Informal document **GRVA-13-20**
13th GRVA, 23 - 27 May 2022
Provisional agenda item 8(a)

Mandatory ESC on 4-axles concrete mixer vehicles

Industry proposal

8x2

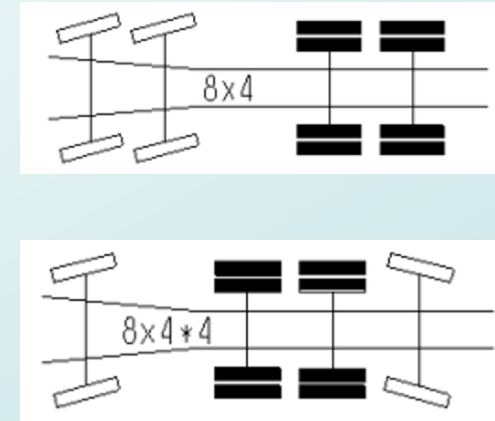
- Very few concrete mixers are 8x2
- Complex variants
- Low volumes

8x4

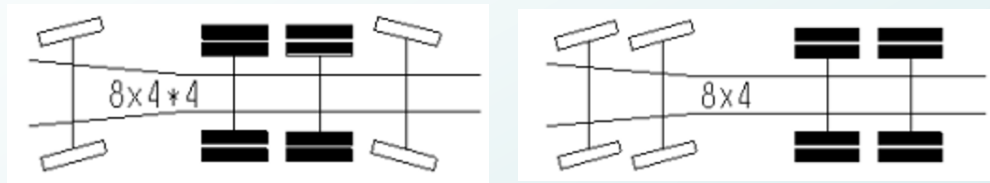
- Most of concrete mixers are 8x4 or 8x4*4
- High volumes (among 4-axles)

The proposal is to focus on those vehicles
